## Why did Shur-Co® re-design the Single Bow Bracket?

### EXAMPLES OF INSTALLATION

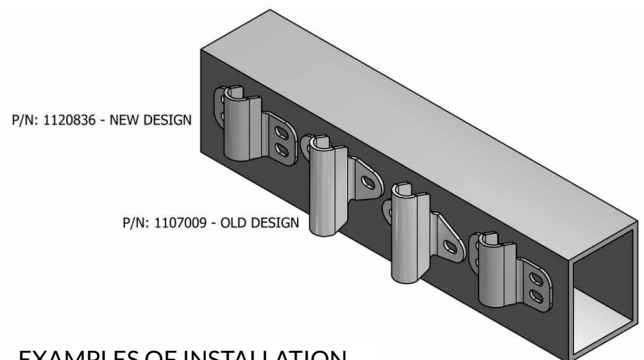
Shur-Co® changed the design of all **Single Bow Bracket** galvanized steel bow configurations to incorporate our two most commonly used steel bow brackets: Single Bow Bracket P/N 1107009 and Universal Bow Bracket P/N 1115702. The new bracket has two holes on each side to allow for more adjustability.

Examples of this product improvement are pictured at the left, including how the new bow bracket is used on differently configured box rails.

*Top: The old bow bracket design is pictured on the left. The new bracket's top hole is used on box rails that are 3 inches or less while, for box rails that are over 3 inches in width, the bottom hole is used.*

*Bottom: The old universal bow bracket is shown at left. The new bracket is the appropriate choice for most lip-in box rails, using the top hole.*
